OAK RIDGE NATIONAL LABORATORY
OPERATED BY MARTIN MARIETTA ENERGY SYSTEMS, INC.

October 24, 1984

Enclosed is the final draft of the topical review "Review and Assessment of Radionuclide Solubility Information for the Basalt Waste Isolation Project Site." This report has been internally peer reviewed and edited. Please have the document technically reviewed as soon as possible so it can be published as an NRC NUREG report.

REVIEW AND ASSESSMENT OF RADIONUCLIDE SOLUBILITY INFORMATION
FOR THE HANFORD, WASHINGTON, CANDIDATE HLW REPOSITORY SITE

Fig. 1. Schematic illustration of solution concentration as a function of time for a hypothetical barrier materials + groundwater system.

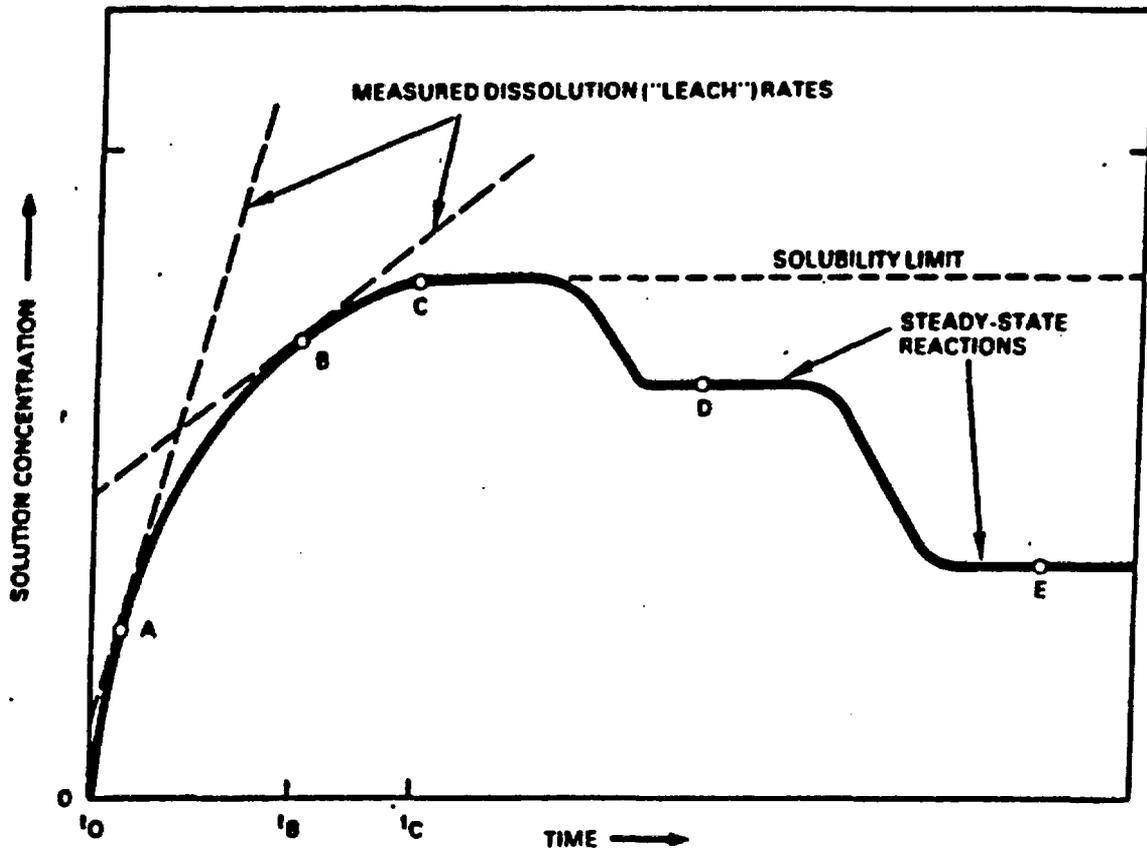
7. Some comments concerning "the Volkswagen diagram" — There are three confusing aspects of figure 2 in Apted (1982a) (see Fig. 1). (For reasons which are readily apparent upon examining this figure, it is frequently referred to as "the Volkswagen diagram.") This figure is important because it illustrates graphically what BWIP staff members are claiming is a general rule-of-thumb concerning the concentration-vs-time behavior of dissolved radionuclides.

First, Apted does not indicate specifically that the figure refers to reactions/equilibria in a closed, isobaric, isothermal system. This must be the situation because, otherwise, much of the explanatory discussion that he presents is either misleading or erroneous.

Second, the figure indicates that, after a sufficient period of time — specifically, after time t_c — a series of steady states are reached, and for each steady state the concentrations of solutes remain more-or-less constant. As noted by Apted, these "solubility limits" of metastable phases actually represent transitory periods during which time a delicate balance exists between dissolution, precipitation, and ion exchange. However, because the rates of these reaction processes can be affected by such variables as the surface areas of solid phases, the kinetics of nucleation and growth of precipitated crystals, etc.,

Third, the figure is misleading in that it implies that steady-state concentrations of radionuclides dissolved in groundwater in a closed isobaric, isothermal system must decrease with increased time. This is not necessarily so. A closed multi-solid-phase hydrothermal system will, with time (i.e., upon conversion of highly metastable to less metastable phase assemblages), evolve toward lower total free energy states, and the amounts of dissolved radionuclides may either decrease or increase depending on: (1) the values of radionuclide solid-phase/groundwater partition coefficients, and (2) the reactive surficial masses of the solid phases that are present. (For the sake of argument, it is assumed here that there are no major kinetic barriers to radionuclide "exchange" between groundwater and coexisting solid phases.) This argument holds regardless of whether radionuclide-bearing solids are: (1) precipitated phases in which one or more radionuclides are major components, or (2) secondary minerals (e.g., clay minerals and zeolites) that are present prior to, or form during, hydrothermal alteration, and which contain radionuclides as adsorbed, chemisorbed, or absorbed trace components. Experimental evidence that supports these statements includes the data that BWIP has obtained on the concentration-vs-time behavior of cesium in an experiment performed on the system simulated spent fuel + groundwater + basalt at 300°C. During this experiment — run BSF-3 described by Myers et al. (1983, Table A-8) — the
